**SITE PLAN AMENDMENT
STAFF REPORT**

City Council Meeting Date:
November 10, 2015

Proposed Use: Site plan for PD-724 for Mixed-Use

Companion Cases: SP-15-004/ZC-13-179/PD-724/SP-14-006

Required Primary Street Frontage and Front Yard Setback

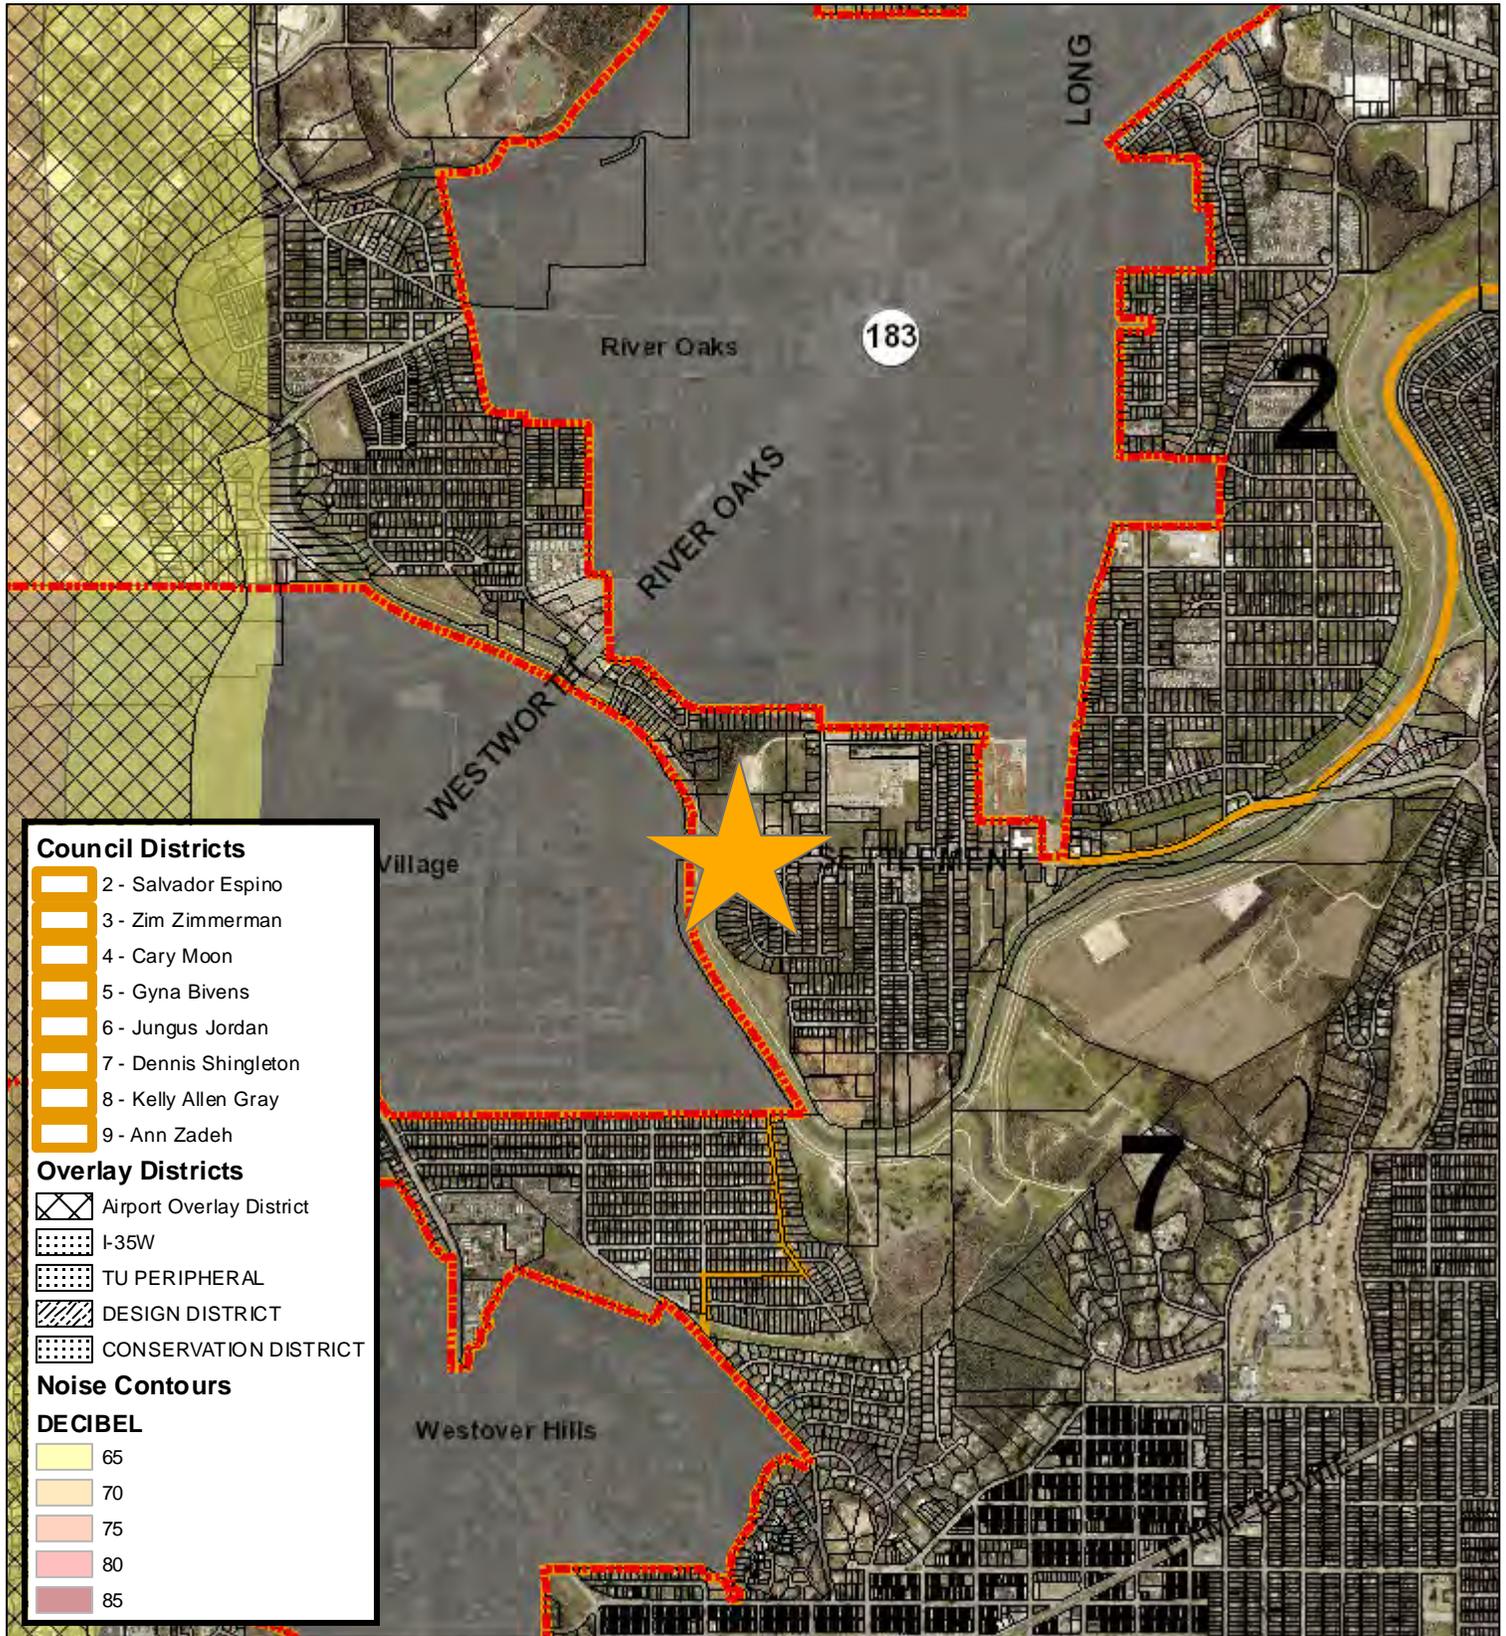
It is design staff's professional opinion that the applicant has provided an acceptable design solution that will create a walkable pedestrian environment while still accommodating the site's legitimate topography constraints. Therefore, **staff recommends approval of the primary street frontage and front yard setback waiver.**

SITE PLAN - PHASE I AND II
BUILDING INFORMATION:

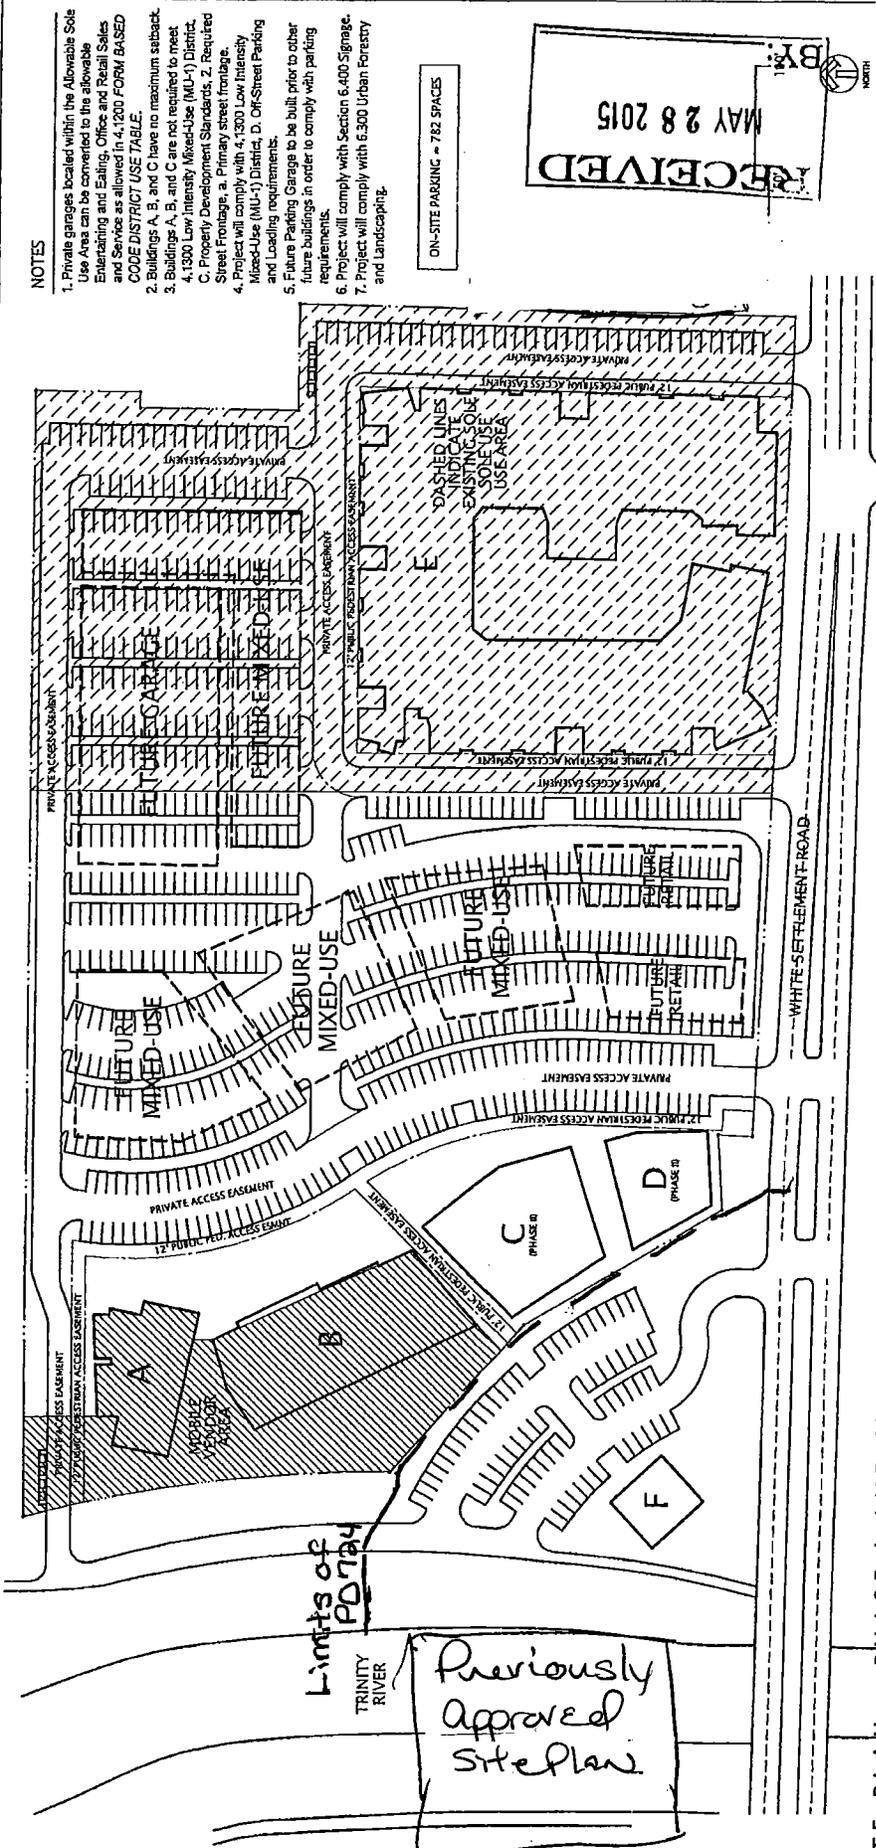
Site Plan Comments:

The site plan as submitted is not in general compliance with the Zoning Ordinance regulations.

1. Indicate the dimensions of drive approaches and widths of street row.
2. Label the gas well setback 300’ on the site plan.

Items noted above shall be reflected on the site plan.
